**RE: Response to Request for Additional Information – DA-2020/035 – 262 Hunts Road
Gunnedah NSW 2380**

Thank you for your letter dated 10 August 2020, which sought additional information regarding the proposed establishment of a solar farm (DA-2020/035) at 262 Hunts Road Gunnedah NSW 2380.

Figure 1 – Site Aerial (Source: Google Maps)

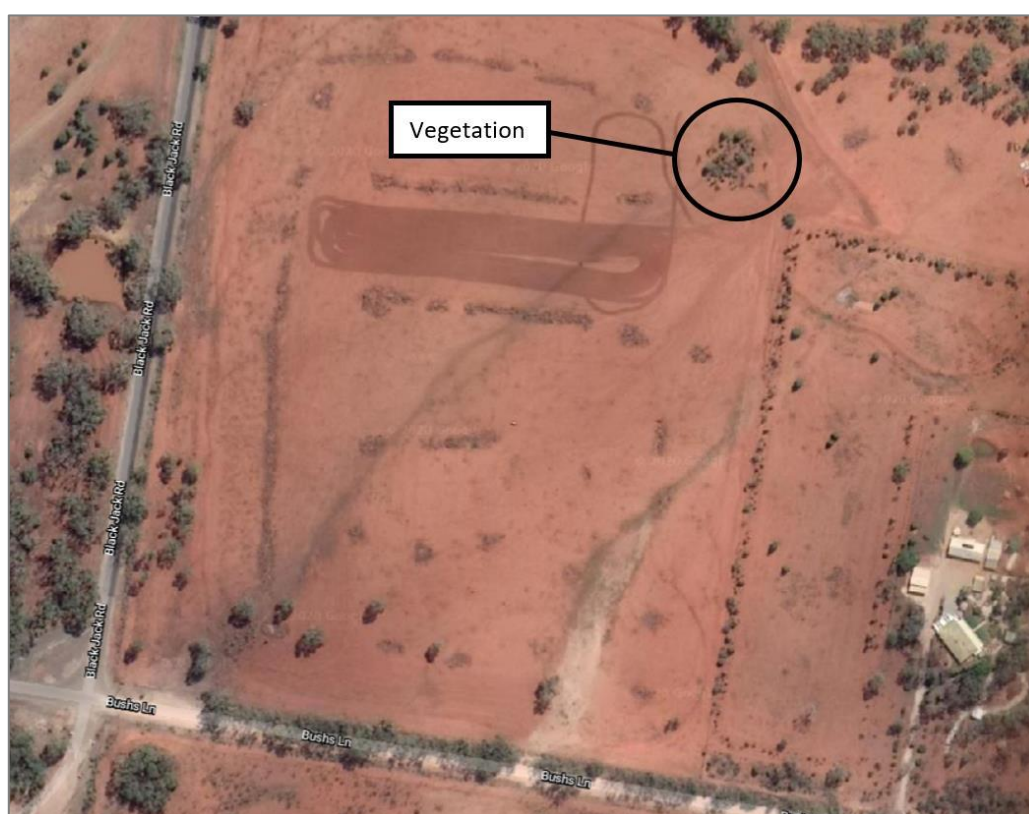
6 Clarify the retention of vegetation in North-West corner of the site as development plans indicate the placement of panels within this area.

It is understood that point 6 refers to the vegetation located within the north eastern corner of the site, refer to site aerial at Figure 1 below.

This vegetation consists of immature shrubs, including *Callitris glaucophylla* (White Cypress) and will be required to be removed to facilitate the proposal. The FFAR has been updated to reflect this removal, refer to Enclosure B.

Figure 1 – Residential Phasing Plan Extract – Area M

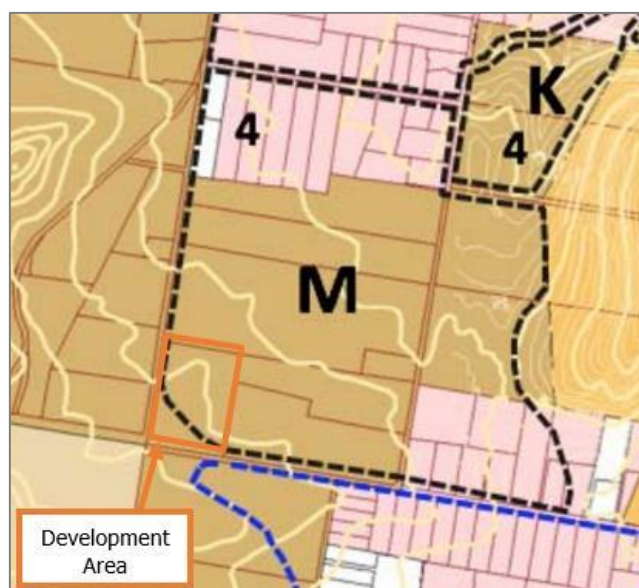
The development is inconsistent with Councils Urban Land use Strategy

It is acknowledged that part of the development area is located within a Residential Phasing area noted within the Gunnedah Urban Landuse Strategy. The site is located within Area M and is noted to retain the existing RU4 with R5 with a re-evaluation once Areas D, F and H are exhausted.

The development area is located on the very south western corner of Area M with a large portion of the development area located outside of Area M, see Figure 1.

The location of the development area at the boundary of the area allows for sufficient area for any future residential expansion if deemed to be required by Council once the existing housing stock has been exhausted. The proposed landscaping, while designed for existing proximate residential properties will continue to provide effective visual buffering to any future residences in the area.
